**SECTION: 417****Service Action: Right-Hand Rear Lamp LED Failure****AFFECTED VEHICLE RANGE:**

XF (X250)

VIN: R00001 - R61290

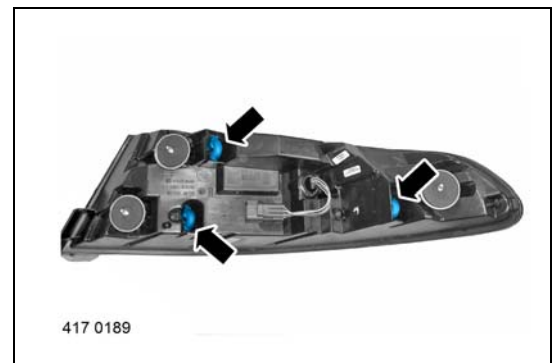
1. Turn the exterior lights 'ON'.
  - If the right-hand (RH) rear lamp assembly LEDs are functioning correctly, perform steps 2-4 below only.
  - If the RH rear lamp assembly LEDs are not functioning correctly, perform step 5 below only.
2. Refer to Workshop Manual, section 417-01: *Exterior Lighting*, and remove the RH rear lamp assembly.
3. Replace the vent tubes:
  - Release and remove the three (3) vent tubes from the lamp assembly.
  - Install three (3) new vent tubes to the lamp assembly.
4. Refer to Workshop Manual, section 417-01: *Exterior Lighting*, and install the RH rear lamp assembly.

- △ **NOTE: New lamps do not require vent tube installation.**
5. Refer to Workshop Manual, section 417-01: *Exterior Lighting*, and replace the RH rear lamp assembly.
